CITY OF YORK
LOCAL PLAN
Site Selection Paper Addendum
September 2014

Non-Strategic Site Addendum **Page 19**

SUBMITTED SITE PLAN

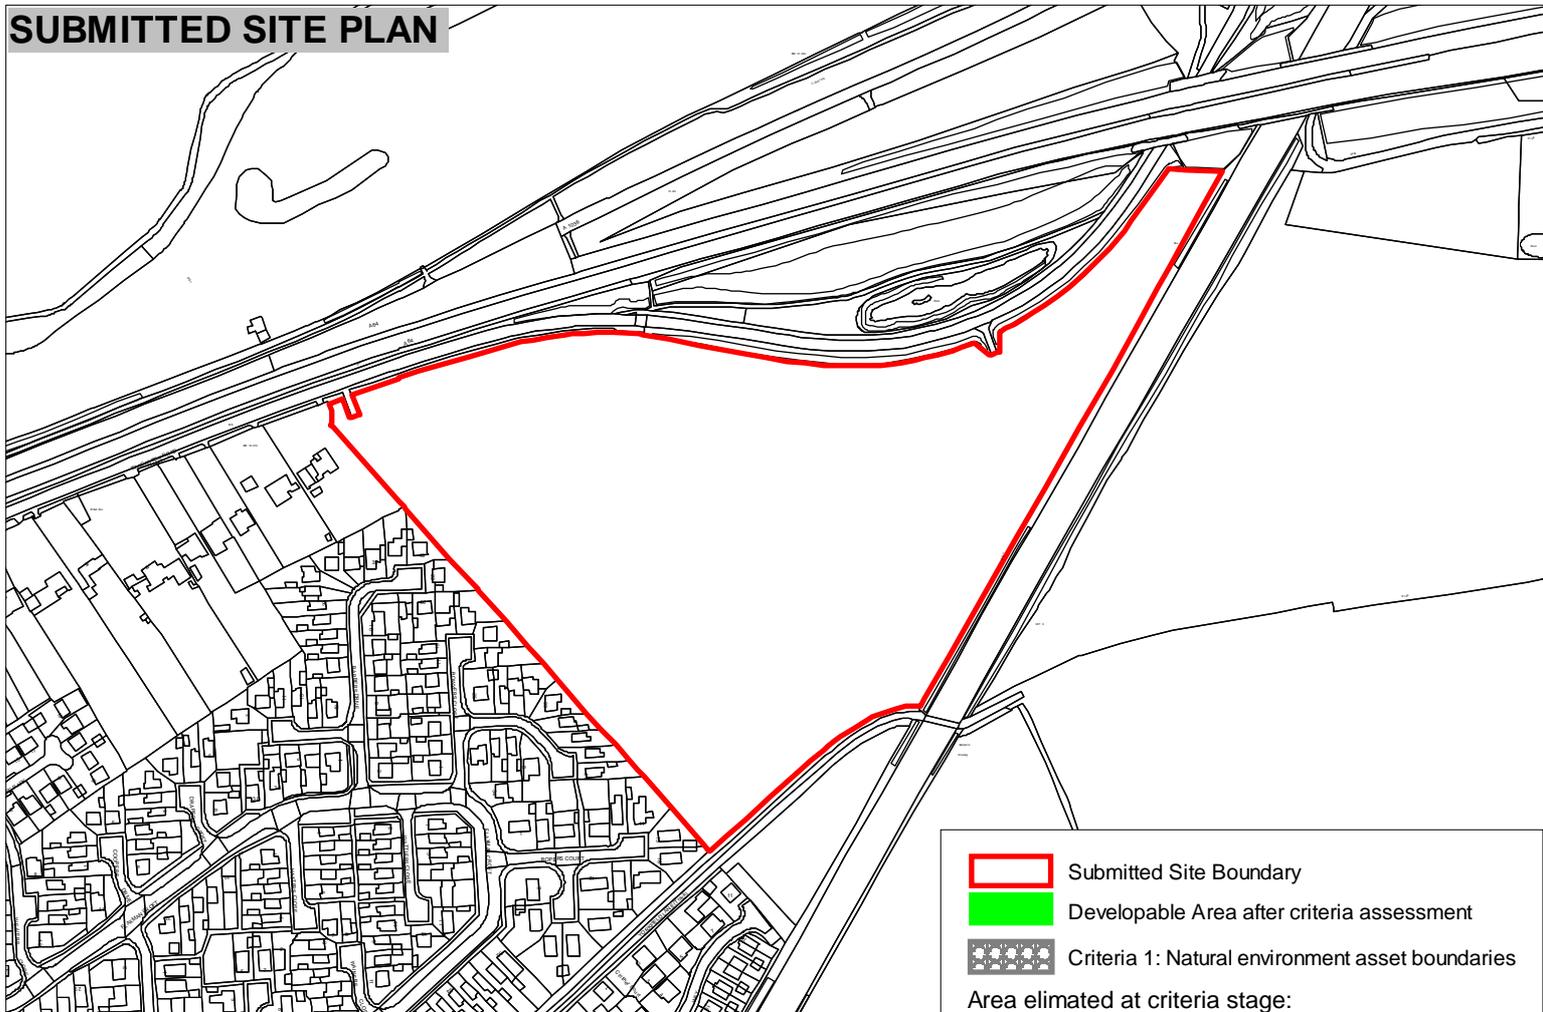
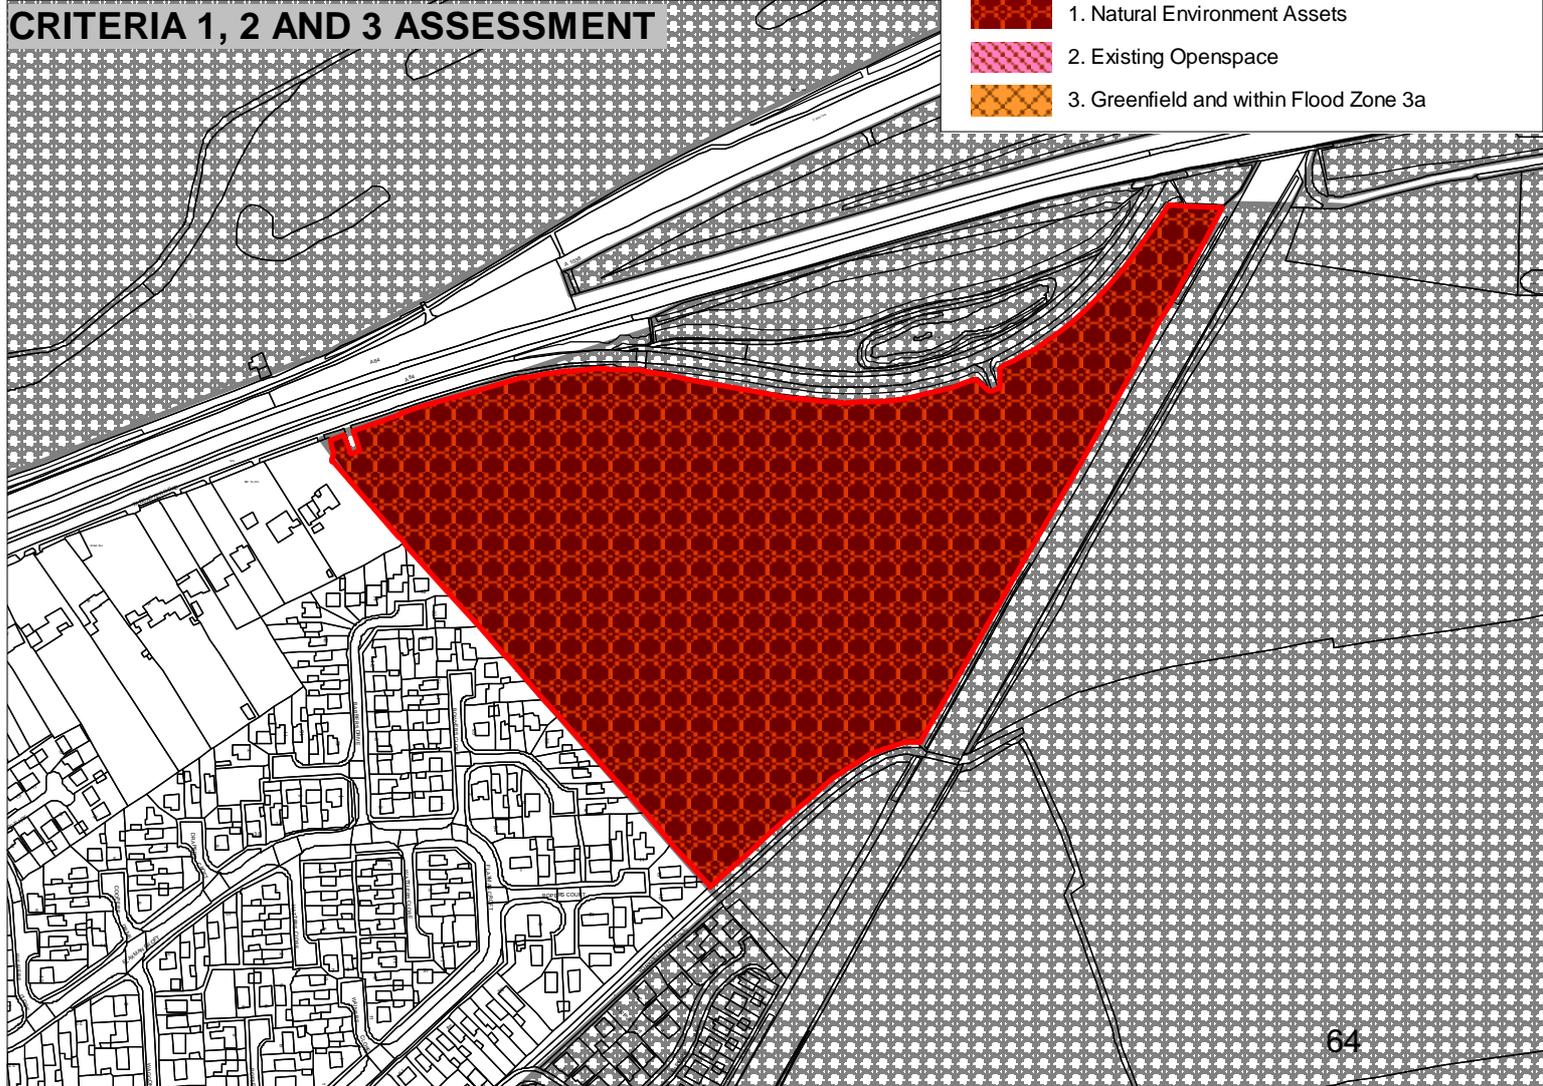
ID Ref:	ID1705
New site ref:	
Original Site Ref Number:	185
Allocation Ref:	
Site Name:	Land South of Tadcaster Road, Copmanthorpe
Submitted for:	Housing
Agent:	Gladman Development

Response submitted by:	Craig Barnes
On behalf of:	Gladman Development
Additional Evidence Through FSC:	Yes - Greenbelt Settlement Study
Summary of Response Received:	Object to failure of site in FSC. Fails criteria 1 (HC&S) area preventing coalescence and criteria 4 (access to services). Dispute coalescence argument as existing gap between Copmanthorpe, York and Bishopthorpe will remain open in event of the sites development and it is protected by Askham Bog to north and flood zone to east. Site boundaries are well defined. Copmanthorpe Neighbourhood Plan promoting inclusion of site. Site is within walking distance to new Askham Bar Park and Ride and has access to Number 13 bus route and Coastliner. Submit greenbelt settlement study
Flooding/Drainage:	Site is greenfield therefore runoff rates must comply with the 1.4 l/sec/ha. GREEN
Landscape Comments:	The land provides valuable separation between urban edge and ring road thereby retaining the characteristic setting of the city. This site prevents coalescence between Copmanthorpe and Dringhouses. The further evidence submitted has been reviewed but does not change the value of this land in preventing coalescence. RED

services, and access to open space. AMBER
Archaeology Comments:	An archaeological desk based assessment will be required to identify features and deposits. AMBER
Retail Comments:	n/a
Proposals Map Action Required:	N/A
Trajectory implications:	N/A
ID:	19
Officer Recommendation:	The site fails criteria 1 of the Site Selection methodology as it falls within an area preventing coalescence (Historic Character and Setting). The submitted evidence does not change this and it is considered that the site provides valuable separation between urban edge and ring road thereby retaining the characteristic setting of the city. This site prevents coalescence between Copmanthorpe and Dringhouses. The site also fails criteria 4 (access to residential services) and despite the relocation of the Park and Ride the A64 still severs the access. The location of the site means that access on foot to local services is at or beyond the maximum acceptable/attractive/likely distance to bus services on Tadcaster Road and Flaxman Road will exceed for most of the site. Assessment of the potential for new stops to Tadcaster Rd frontage (and service improvements based upon cumulative village impacts) would be required. The viability and attractiveness of non motor access via Yorkfield Lane needs evidence and again distances to local services would be likely to score low. There is lack of other sustainable connections to village and the site is likely to be car dependant. The further submission does not provide robust detail of access by sustainable modes to local facilities. REJECT - NO CHANGE

SUBMITTED SITE PLAN

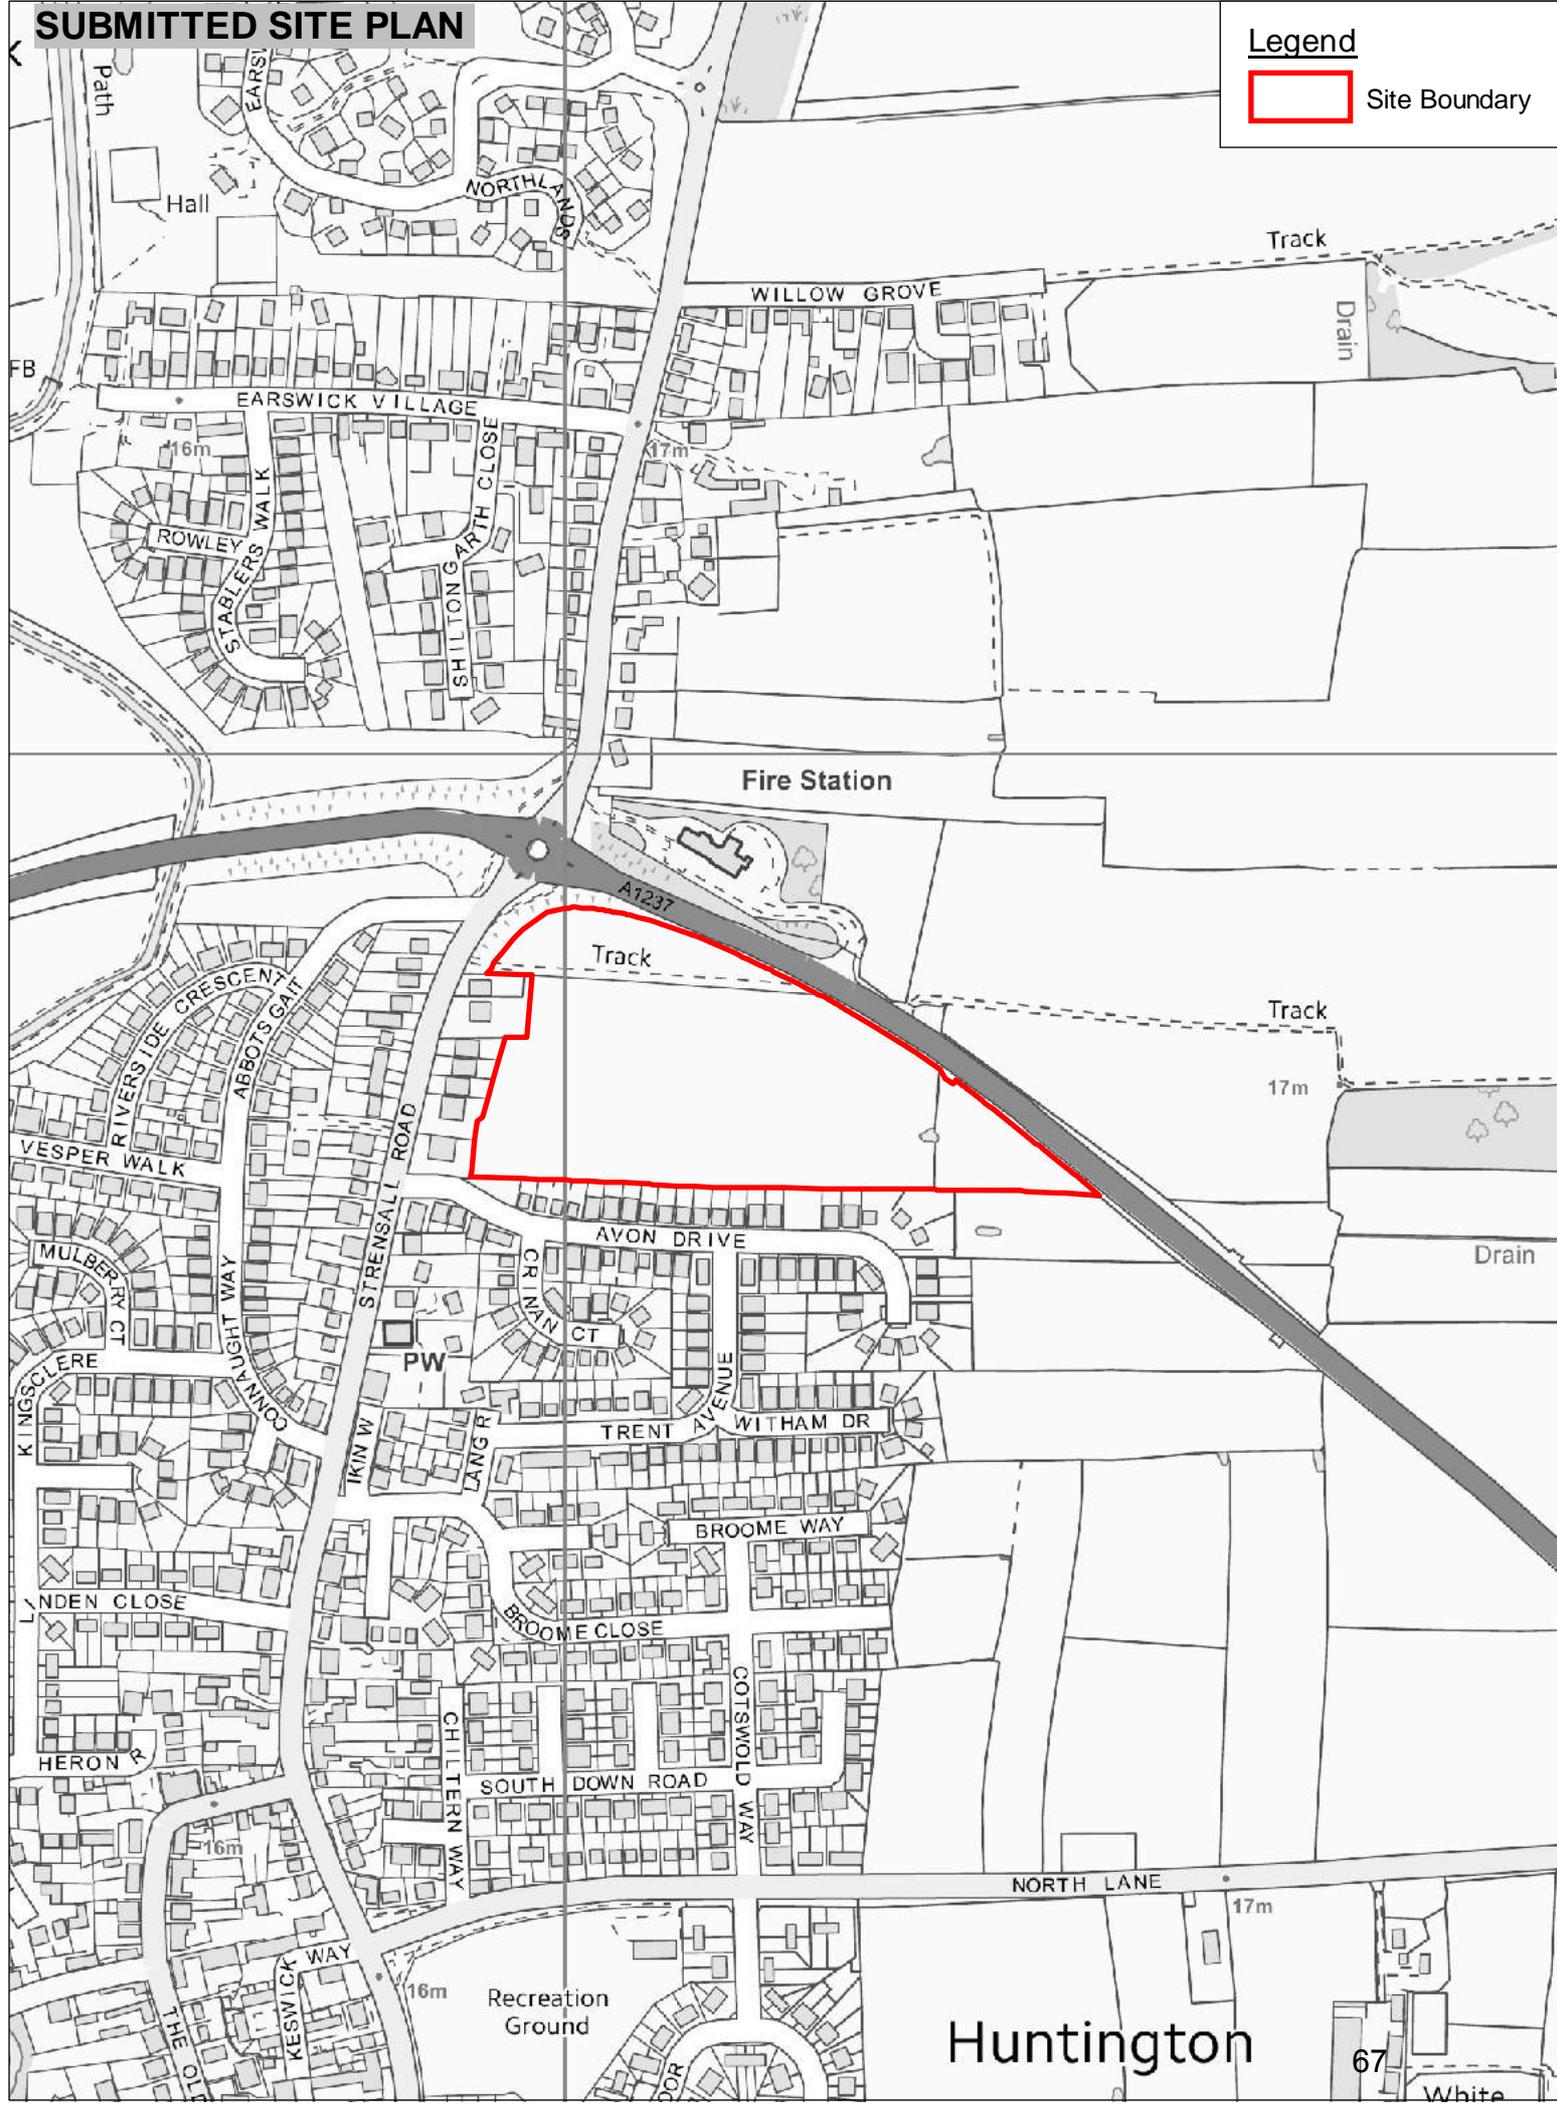
ID Ref:	ID1289
New site ref:	
Original Site Ref Number:	191
Allocation Ref:	
Site Name:	Land at Avon Drive, Huntington
Submitted for:	Housing
Agent:	Signet Planning

Response submitted by:	Jim Ramsay
On behalf of:	Pilcher Homes
Additional Evidence Through FSC:	Yes - revised masterplan and transport drawings
Summary of Response Received:	Site rejected in FSC due to transport comments - land required for dualling and grade separation which would undermine viability of site. Further technical drawings submitted which show that sufficient land remains available to provide an appropriate landscaped buffer. Submit revised illustrative masterplan and transport drawings
Flooding/Drainage:	
Landscape Comments:	It is considered that development will affect the openness as viewed from the Ring Road and bring development right up to the ring road. The site is not large enough to provide the buffer that would be required to retain the open setting and to prevent coalescence. If further land is required as shown in the submitted drawings then this further reduces the site area and the land available to create the required landscape buffer. RED

Ecology Comments:	Development may impact on the land to the east and to the SINC site. May also be issues with ecological linkages. Habitat survey and Great Crested Newts survey required. AMBER
Transport Comments:	Original comments at FSC - As significant land is required for the dualling and grade separation of the ring road, and the widening of the roundabout, a significant part of the land may need to be taken which would undermine the viability of the remaining site area. In addition further land would be required to buffer the revised road layout which would compromise the site further. There may be constraints regarding the Yorkshire Water pipeline and large pipe implications. The additional submission does not provide substantive detail on the extent of the site which would be effected by upgrades to the A1237 it would however appear that such works will not entirely preclude a reduce number of units being achieved, with access from Avon Drive. AMBER

EDU comments:	N/A
Open Space Comments:	N/A
Archaeology Comments:	No further comments to FSC
Retail Comments:	N/A
Proposals Map Action Required:	N/A
Trajectory implications:	N/A
ID:	20
Officer Recommendation:	The additional submission does not provide substantive detail on the extent of the site which would be effected by upgrades to the A1237 it

would however appear that such works will not entirely preclude a reduce number of units being achieved, with access from Avon Drive. It is considered that development will affect the open setting as viewed from the Ring Road and bring development right up to the ring road. The site is not large enough to provide the buffer that would be required to retain the open setting and to prevent coalescence. If further land is required as shown in the submitted drawings then this further reduces the site area and the land available to create the required landscape buffer. On balance whilst recognising that technically there may be some opportunity for development despite the area of land that would be required for the future dualling of the northern ring road it is still considered that the remaining land would not be large enough to create the significant landscape buffer that would be required to address concerns regarding landscape setting and coalescence. REJECT - NO CHANGE
